MEMORANDUM

REVIEW: Amendment to Preliminary Forest Conservation Plan No. MR1994002
TYPE Glenmont Station Parking Structure (Mandatory Referral No. MR2009737)

LOCATION: West side of Georgia Avenue, north of Urbana Drive,
Wheaton, MD

1993 Approved Preliminary Forest Conservation Plan

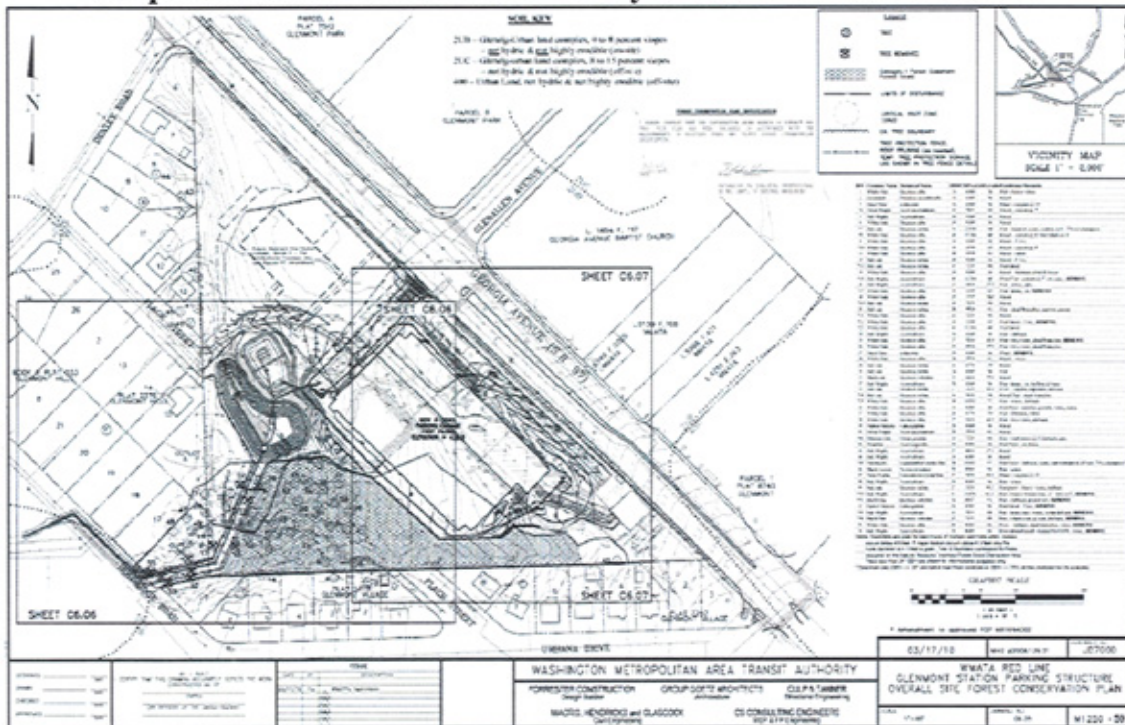
The current submission is an Amendment to the 1993 FCP. It proposes to preserve 1.54 acres of existing forest. Staff had originally recommended that the FCP be revised to save more of the existing forest particularly near the existing homes near the south segment of Flack Street. Staff had recommended that the garage be shifted northwestward away from the existing homes and forest. However, WMATA and the Montgomery County Department of Transportation (DOT) have indicated that the northwestern portion of the site is reserved for the future Glenmont Fire Station.

Earlier submissions of the FCP Amendment did not show a layout for the fire station. After staff's repeated comments beginning in October 2009 to minimize forest loss, the applicant only recently submitted a FCP Amendment that showed a very conceptual layout for a fire station on the northwestern portion of the property. It should be noted that the fire station layout is so conceptual that a part of the proposed parking lot and entrance road from Georgia Avenue for the fire station lie outside the limits of disturbance line shown for that part of the site.

The latest submission of the FCP amendment also shows that a minimum 50-foot wide forest retention area can be protected along the southern property line. Staff believes this retention area provides a minimally acceptable buffer for the existing residences on Urbana Drive east of Flack Street from the proposed garage.

Since the FCP amendment proposes to clear forest that was shown on the original FCP to be protected, staff recommends that the amount of compensation be set at 2 acres of forest planting for each acre of protected forest removed. The original FCP required 2.63 acres of forest retention and planting on the subject site. The proposed amendment would retain 1.54 acres of existing forest. The amendment would protect 1.09 acres less forest onsite than the original FCP. Therefore, staff recommends that 2.18 acres of forest be planted offsite. The applicant proposes to use one of the County DOT's planted forest bank, one of which is in the Patuxent River watershed and the other is in the Great
